Dist	COUNTY	ROUTE	POST MILES TOTAL PROJECT	SHEET No.	TOTAL SHEETS
03	Pla	80	0.3/29.3	14	56

3 **REVISED PER ADDENDUM No. 3 DATED MARCH 8, 2011**

STAGE CONSTRUCTION

2 ADDED PER ADDENDUM No. 2 DATED FEBRUARY 25, 2011

CONFORM AT STRUCTURES - STAGE 1A AND 1B

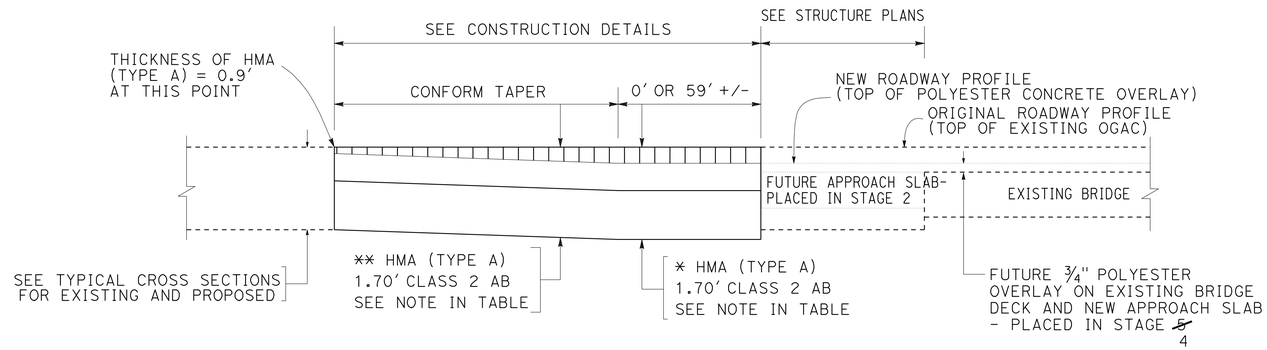
THICKNESS OF HMA (TYPE A) PLACED IN STAGE 1

DIRECTION	BRIDGE	*	**
EASTBOUND	BOWMAN UC	N/A	0.90-0.95′
	BOWMAN OH (SOUTH)	1.00′	0.90-1.00′
	BOWMAN OH (NORTH)	1.00′	0.90-1.00′
WESTBOUND	BOWMAN UC	N/A	0.90-1.00′
	BOWMAN OH (SOUTH)	1.10′	0.90-1.10′
	BOWMAN OH (NORTH)	1.10′	0.90-1.10′

DEPTH OF EXCAVATION AND THICKNESS OF HMA (TYPE A) PLACED IN STAGE 1 SHALL BE ADJUSTED AS REQUIRED TO PROVIDE 0.8′ HMA (TYPE A) AFTER COLD PLANING OPERATIONS IN STAGE 2, OR AS DIRECTED BY THE ENGINEER.

STAGE 4
STAGE 5

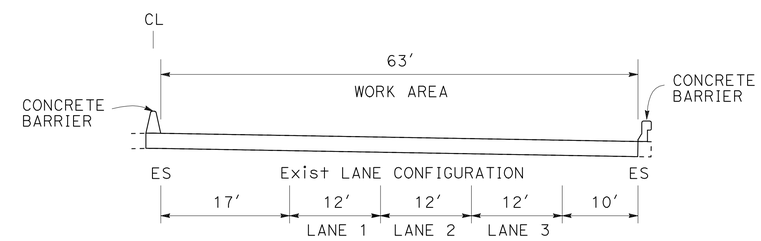
STAGE 4 ~~STAGE 5~~ - PLACE POLYESTER CONCRETE OVERLAY ON EASTBOUND LANES. POLYESTER CONCRETE OVERLAY MUST BE PLACED WITHIN 14 DAYS AFTER REMOVING AC SURFACING FROM BRIDGE DECK. 3

STAGE 5 ~~STAGE 4~~ - COLD PLANE HMA PAVEMENT AND PLACE RHMA (OPEN GRADED) ON EASTBOUND LANES, ONCE STAGES 1-4 HAVE BEEN COMPLETED AT ALL THREE BRIDGES.

3 REVISED PER ADDENDUM No. 3 DATED MARCH 8, 2011

CONFORM AT STRUCTURES - STAGE 2A AND 2B 3

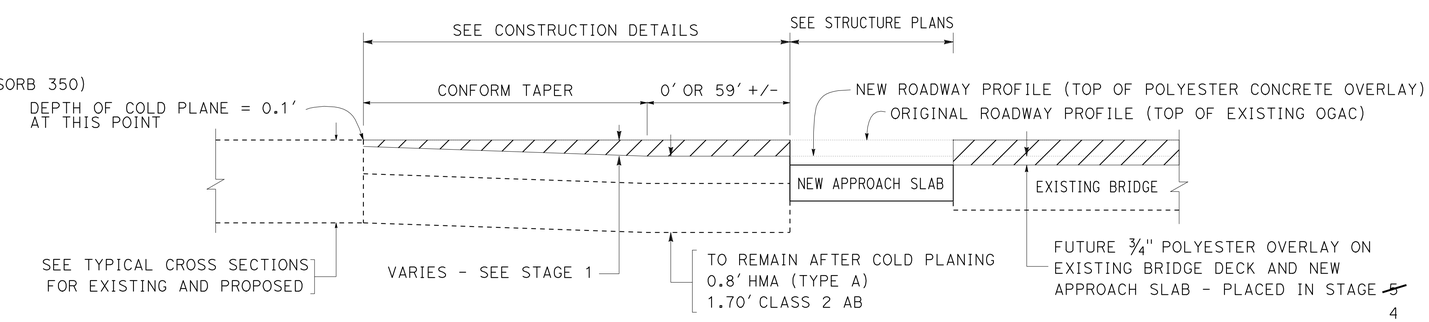
STAGE 2A AND 2B - IN ONE 60 HOUR CLOSURE WINDOW, PLACE NEW EASTBOUND APPROACH AND DEPARTURE SLABS, REMOVE AC SURFACING FROM BRIDGE DECK, AND COLD PLANE OVERBUILT STRUCTURAL SECTION AT CONFORM TAPER. SEE DETAIL A AND CONFORM AT STRUCTURES - STAGE 2A AND 2B DETAIL THIS PAGE, AND STRUCTURE PLANS. 2
